DRAG LINK DESIGN CHANGE

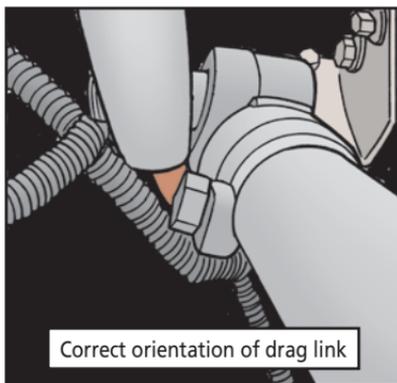
The next time you order the drag link, NSN 2530-01-377-3127, PN 12418103-002, you'll see that it looks different. But the only difference is that there is an adjustable tie-rod end with a clamp on both ends now.

When you get the drag link with the new design, go ahead and adjust the tie-rod ends to match the same length of the drag link being replaced. Turn the steering wheel fully to the left, too. The drag link must be installed with the bend turning to the left to fit correctly. The clamp on the pitman arm side must have the bolt adjusted to the bottom side of the drag link with the bolt entering from left to right and the clamp 1 centimeter to the rear of the pitman arm. Then you won't have interference while turning the wheel.
